NL-20-0843
10 CFR 50.90

Edwin I. Hatch Nuclear Plant – Units 1 and 2
License Amendment Request to Revise the Required Actions of Technical Specifications 3.8.1,
AC Sources – Operating, for One-Time Extension of Completion Time for Unit 1 and
Swing Emergency Diesel Generators

Evaluation of Proposed Change

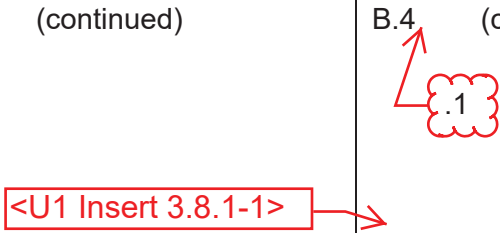
<u>AND</u>
		14 days for a Unit 1 DG with the swing DG inhibited from automatically aligning to Unit 2 and maintenance restrictions met
		<u>AND</u>
		72 hours for the swing diesel with maintenance restrictions not met
		(continued)

Model Change 1

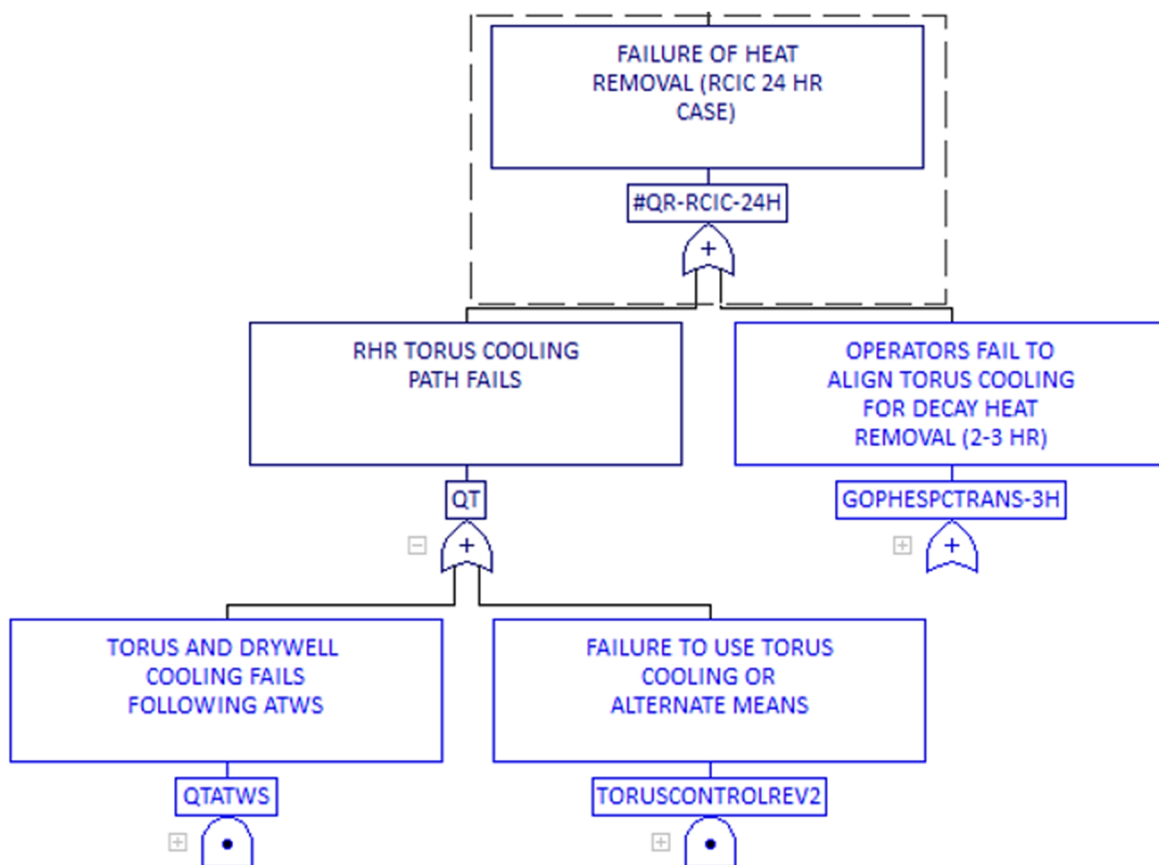
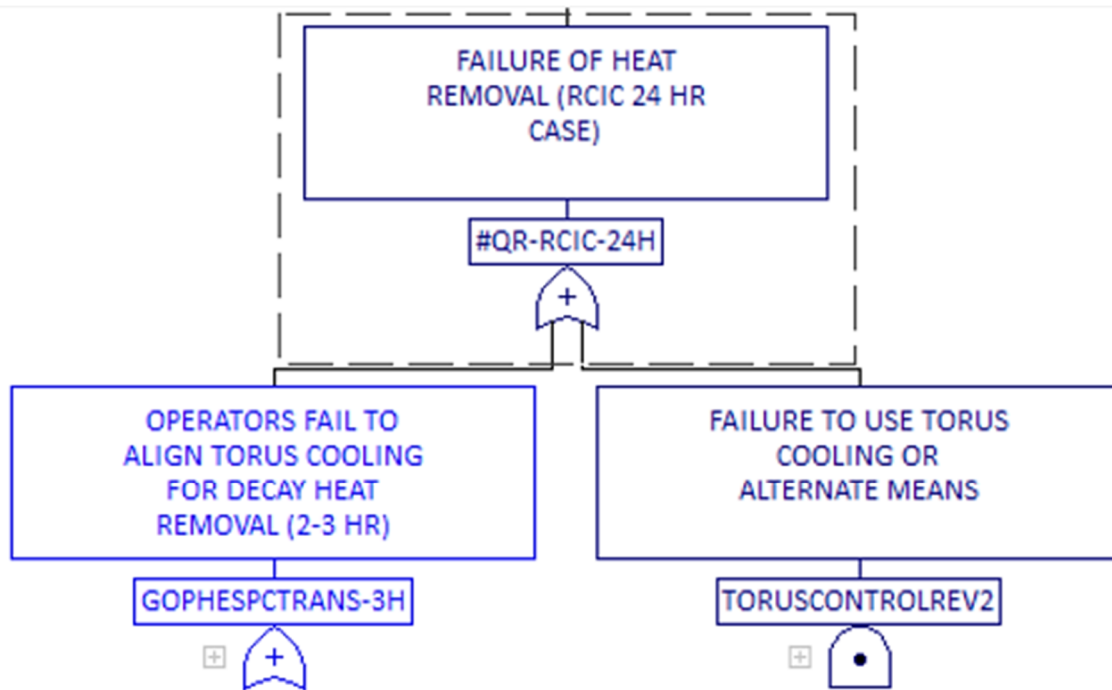
The first change is to correct a model error associated with torus cooling, which removed incorrect ATWS sequences and impacted the internal events quantification only. See Figures 4-1 and 4-2.

Model Change 2

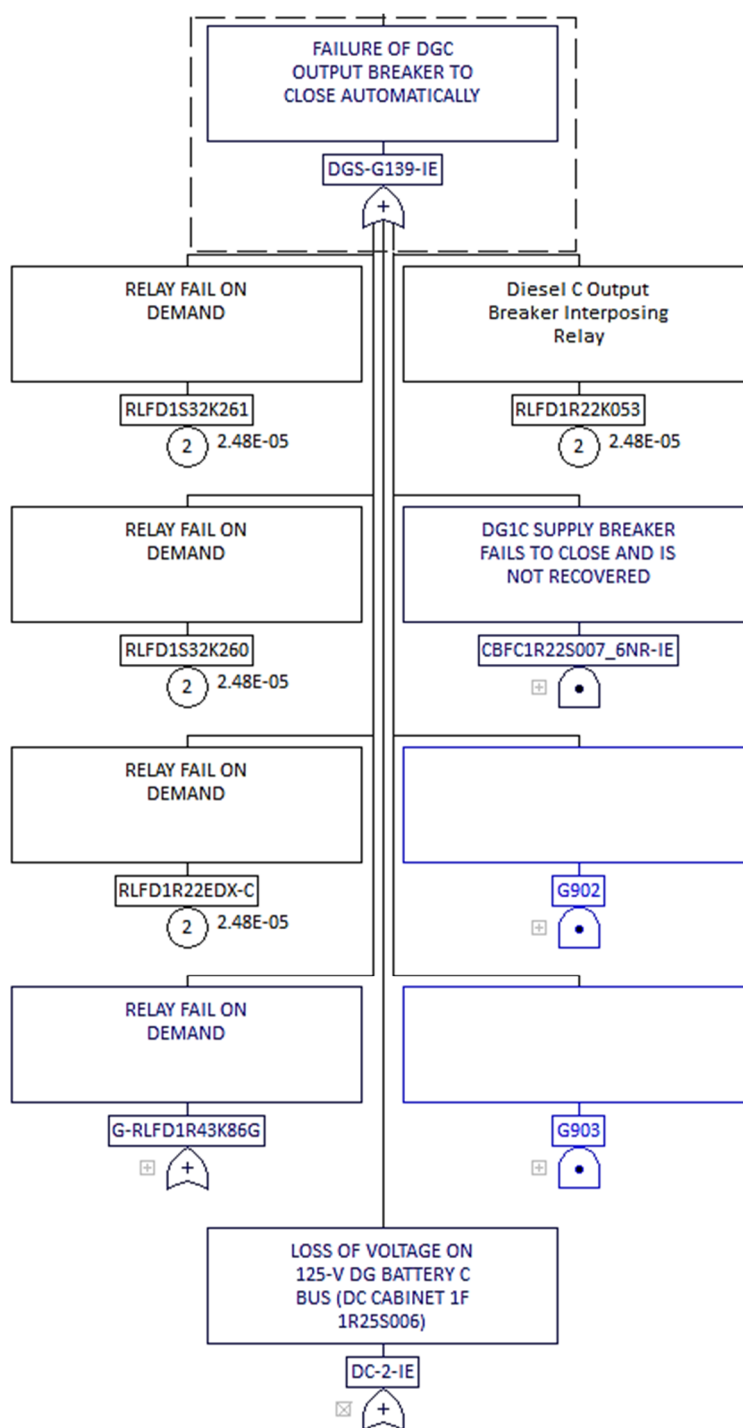
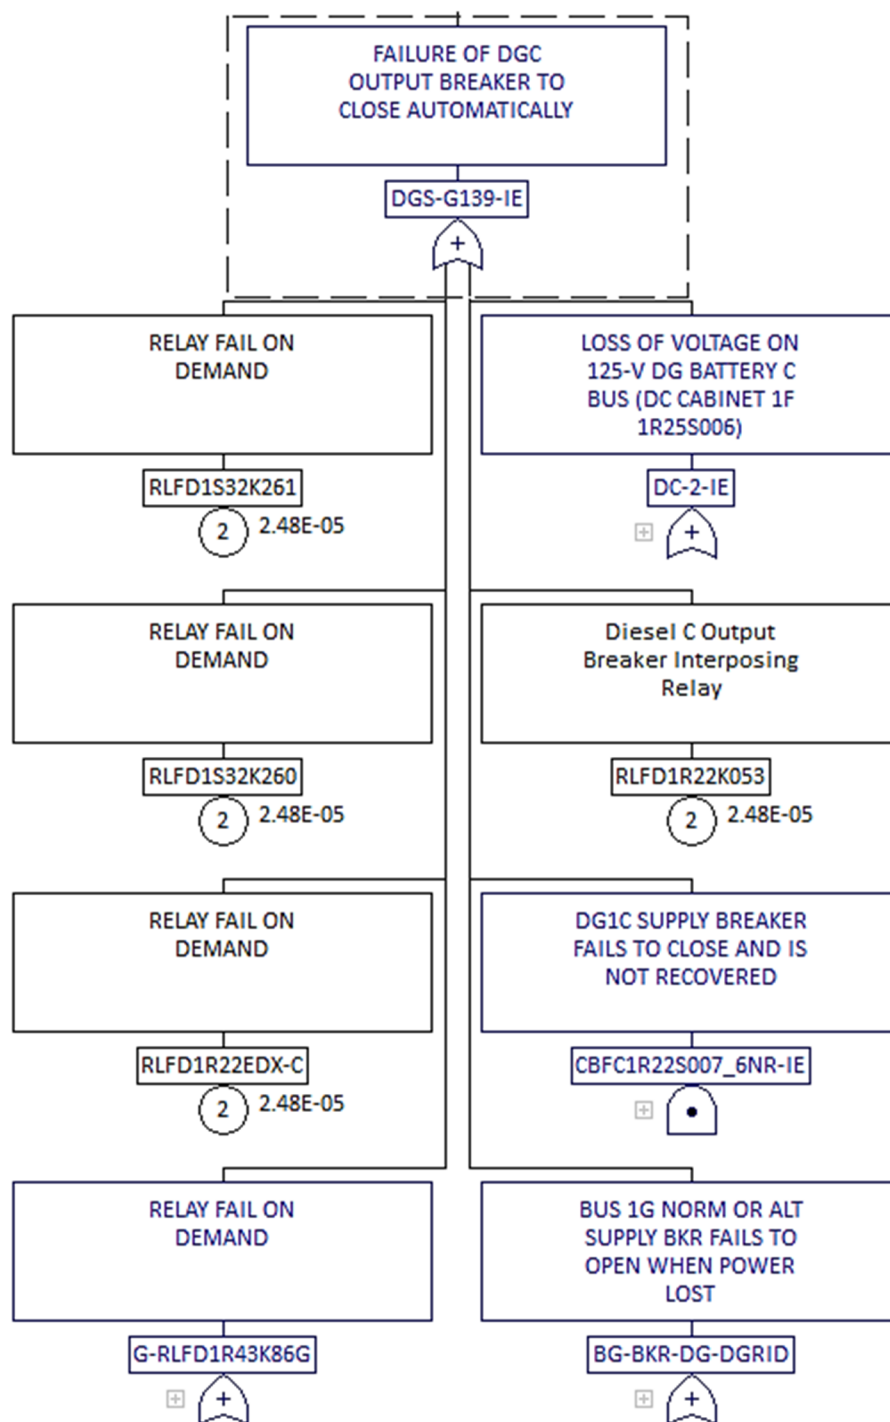
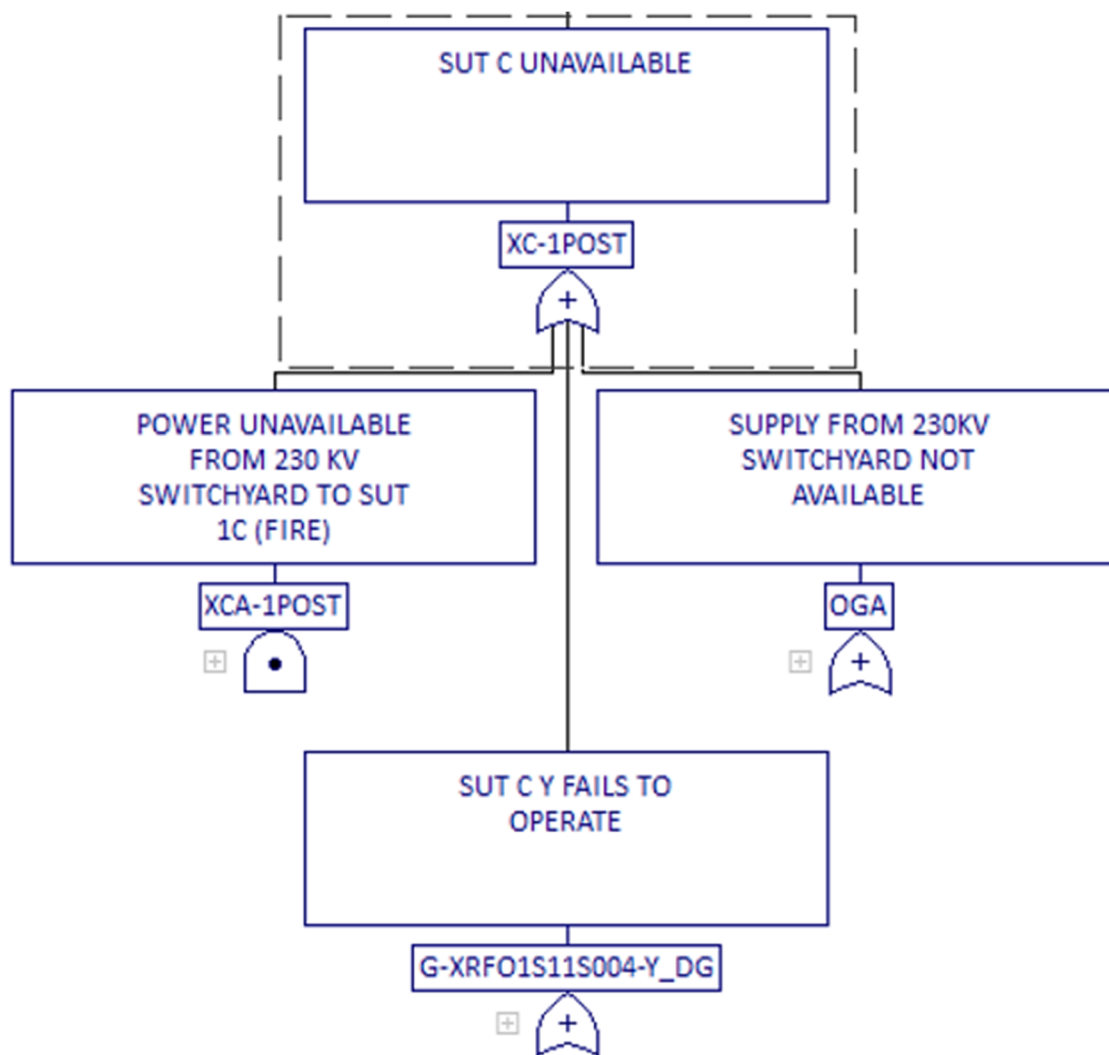
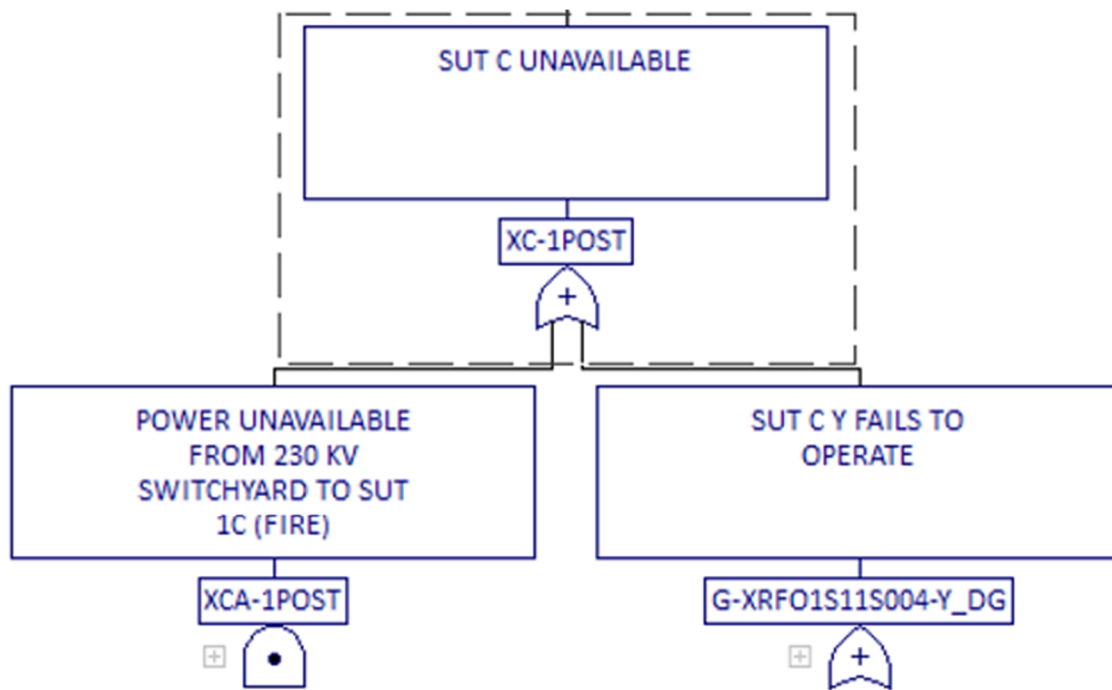
The second set of changes updated the internal events logic for the degraded grid modification similar to the fire logic. This corrects the logic such that it requires a failure of all three station auxiliary transformers (SATs) to lead to a LOOP, as opposed to just two of three. See Figures 4-3 through 4-6.

Model Change 3

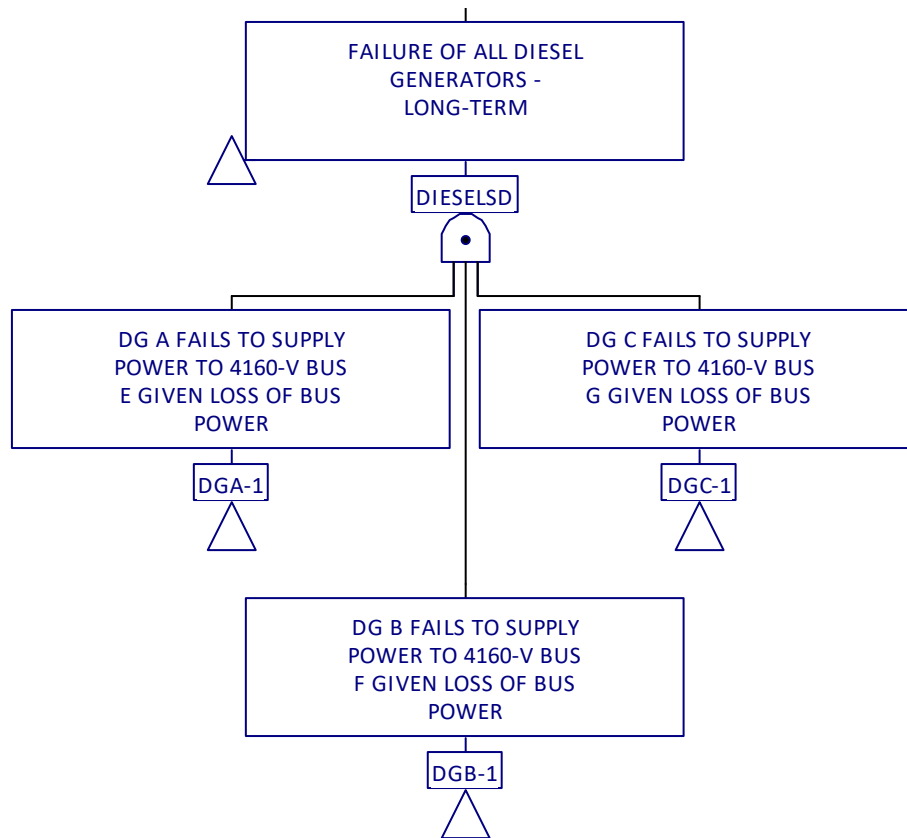
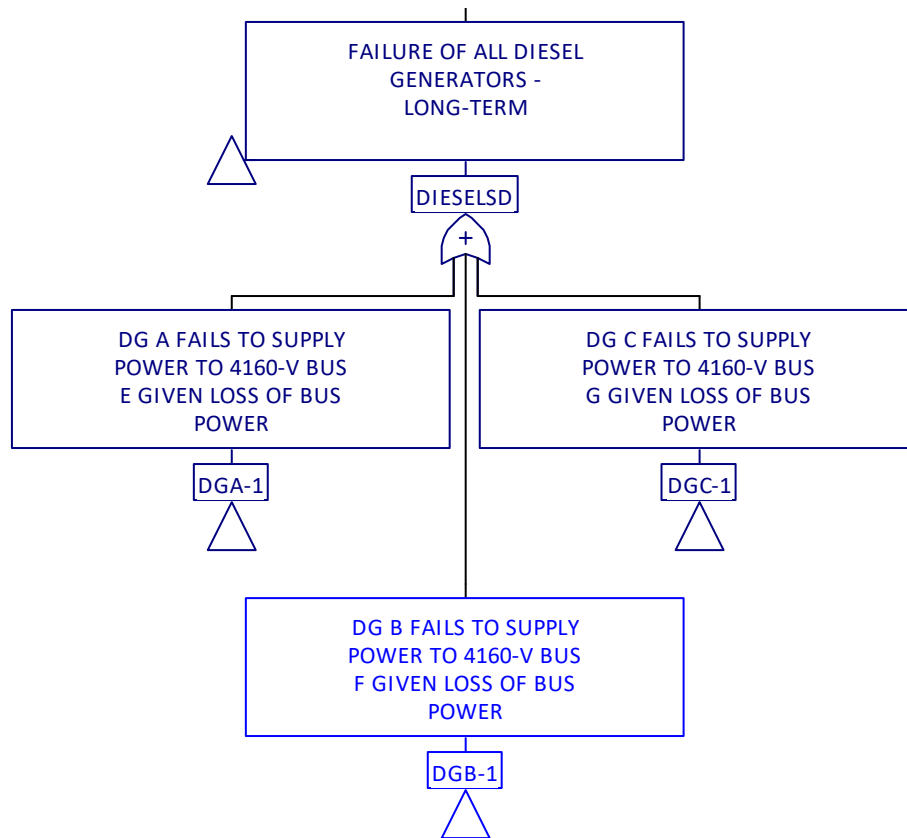
For the third model change, the logic was changed in the consequential LOOP recovery tree allowing credit for recovery of AC power given a consequential LOOP and a single diesel failure, instead of limiting this credit to only SBO sequences (i.e., failure of all emergency AC power). See Figures 4-7 and 4-8.

FIGURE 4-9
ORIGINAL LOGIC

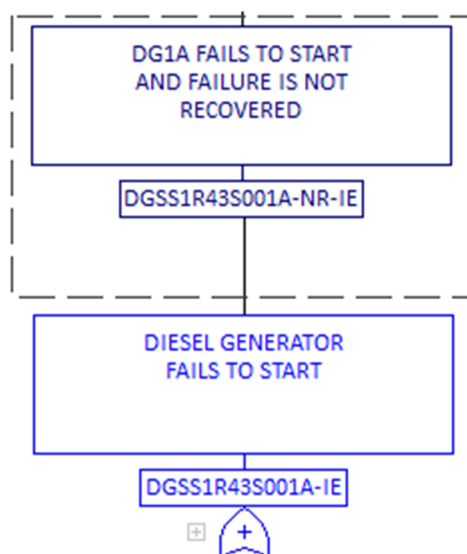
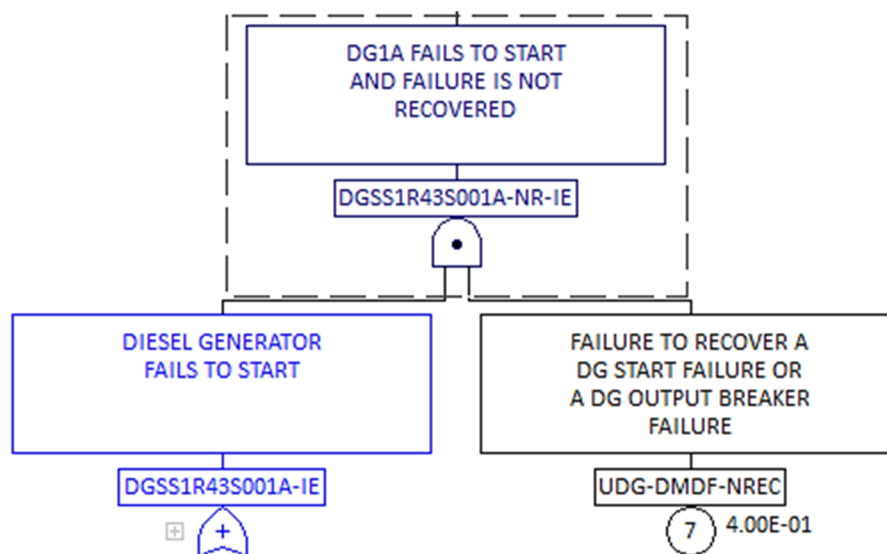
See Figures 4-9 and 4-10 for changes to the failure of DG to start sequence. Logic for DG 1A is shown, logic for DGs 1B and 1C changed identically. See Figures 4-11 and 4-12 for the failure of a DG supply breaker to close sequence. Logic for DG 1B is shown, changes to DGs 1A and 1C are similar.

Model Change 6

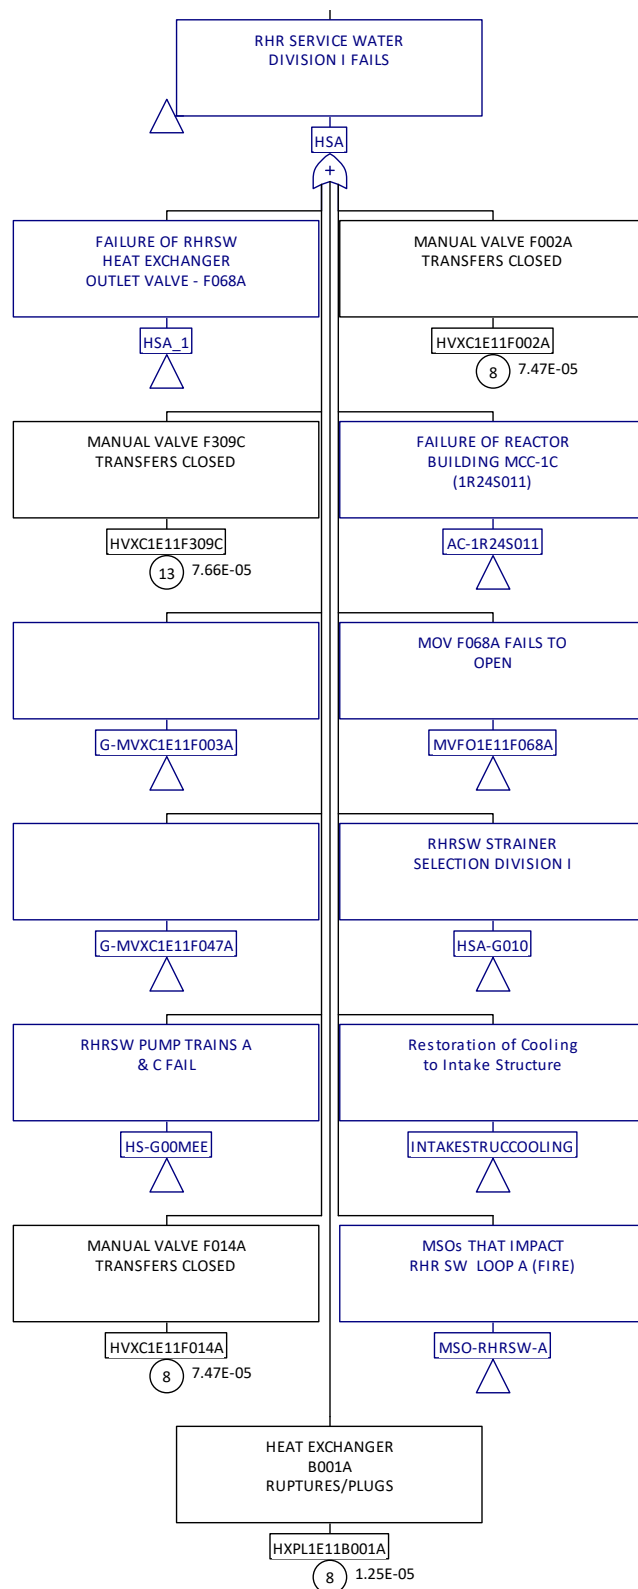
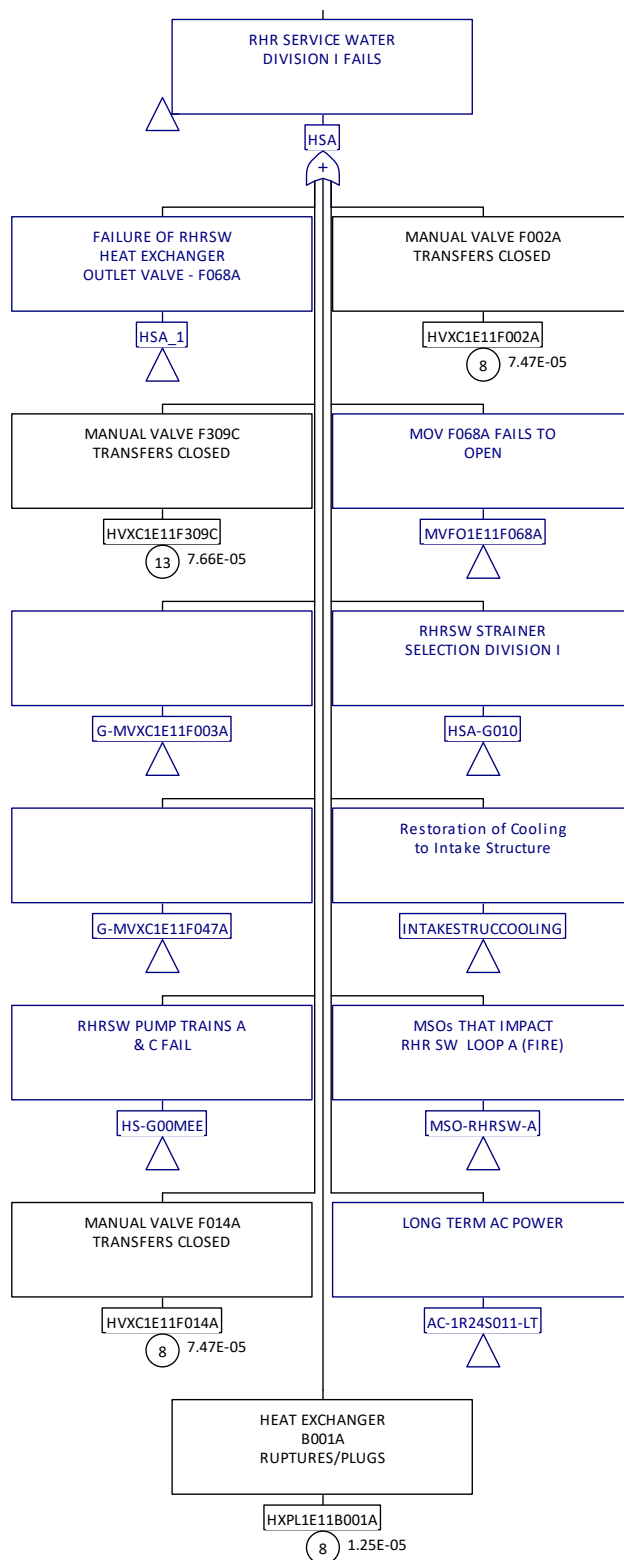
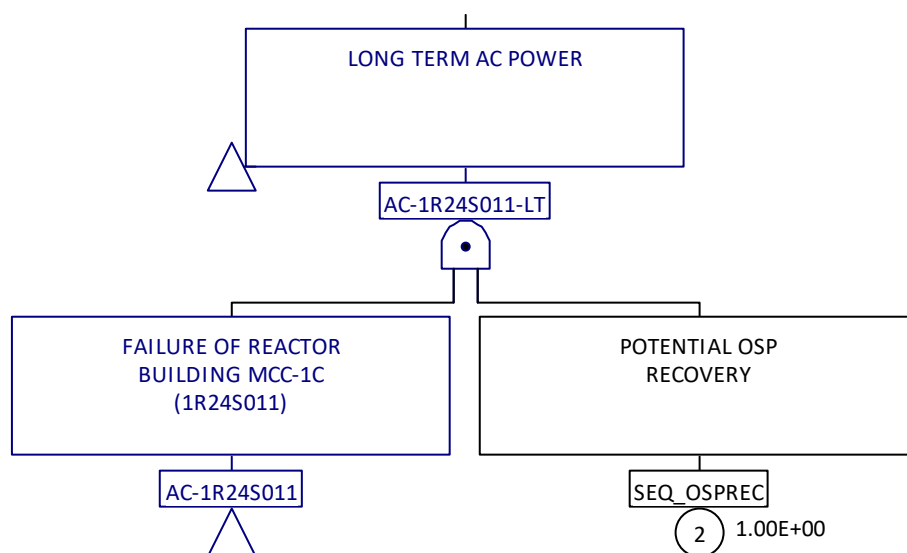
The sixth set of model changes was completed in order to insert a flag used in the updated recovery rule. Figures 4-13, 4-14 and 4-15 show the changes to the HSA gate and the new gate. Changes to HSB and the new gate are similar.
